**From:** Thomas Callaway
**Sent:** 09 July 2014 10:41
**To:** Planning.Responses
**Subject:** RE: Planning Consultation on R/116/14/DOC

| **APPLICATION NO:** | **R/116/14/DOC** |
| **Site Address:** | Sainsburys Supermarkets Ltd Unit C New Road Rustington BN16 3RT |
| **Description of Works:** | Application for approval of details reserved by condition 19 of previously approved planning application R/59/12 - relating to drainage |

Part of surface water drainage

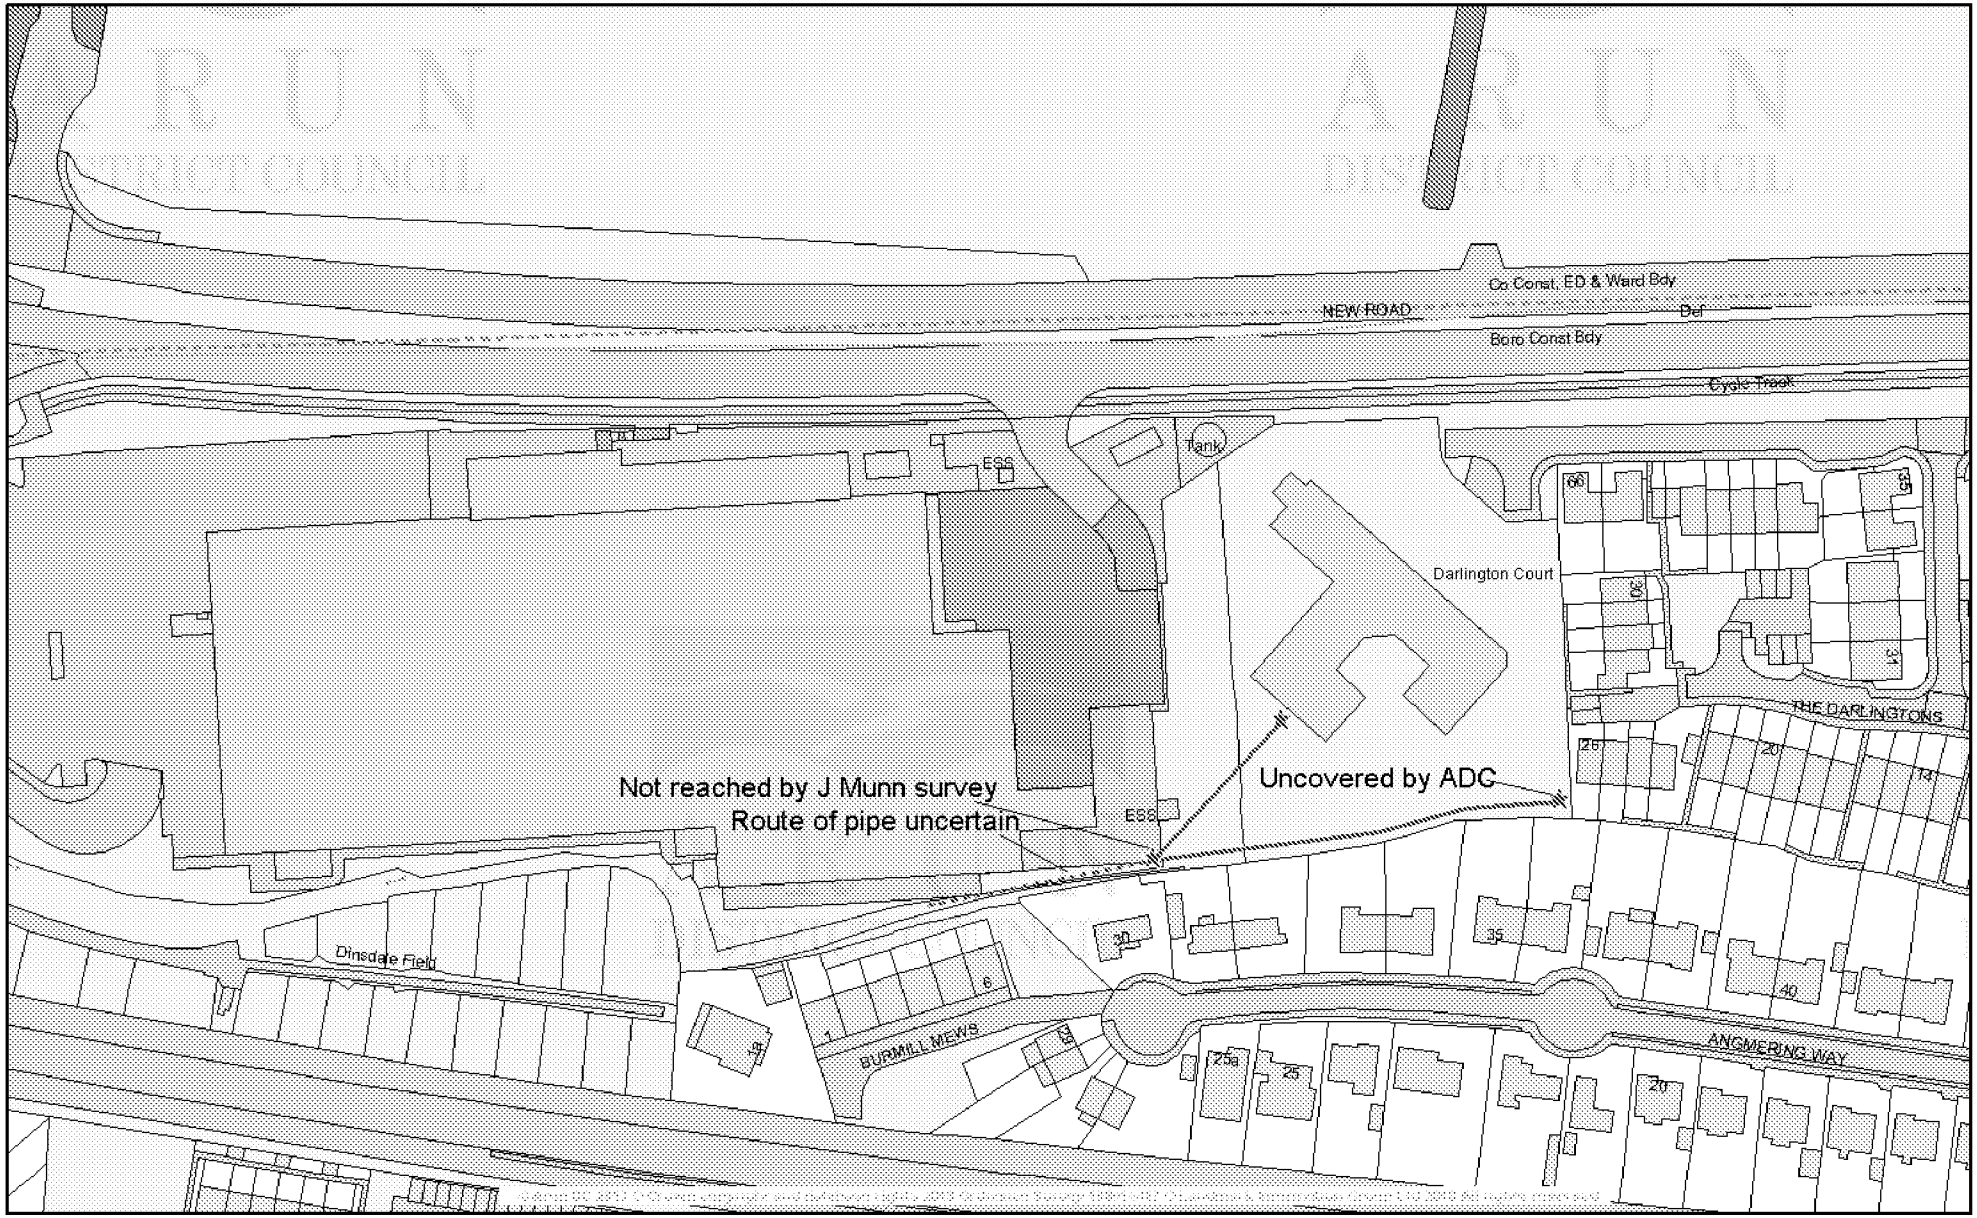
As the site boundary was not reached by the survey, the suggestion that the pipe continues straight off of the site is only an assumption, and the pipe may still return onto the site. The annotated plan of this part of the system shows that no manhole was found by Julian Munn in the SE corner of the nursing home site and the SE corner of the Sainsburys site. We have since investigated the nursing home site and found the manhole relatively quickly, buried under a couple of inches of dirt. The manhole at Sainsburys may also be present, but remains uncovered.

The condition requires provisions for future access and maintenance of existing watercourses and culverts. This part of the system along the southern boundary of the site requires access and also requires surveying to determine the route of the culvert (it may leave the site and return onto the site). Judging from the condition of the system in the nursing home it will also require jetting to clear silt (maintenance). It is therefore a requirement of the condition that the manhole is uncovered and the remaining system surveyed and jetted (these are also riparian responsibilities regardless of planning conditions). We believe that the manhole may be close to the screening fencing for the generator, but we have not investigated further.
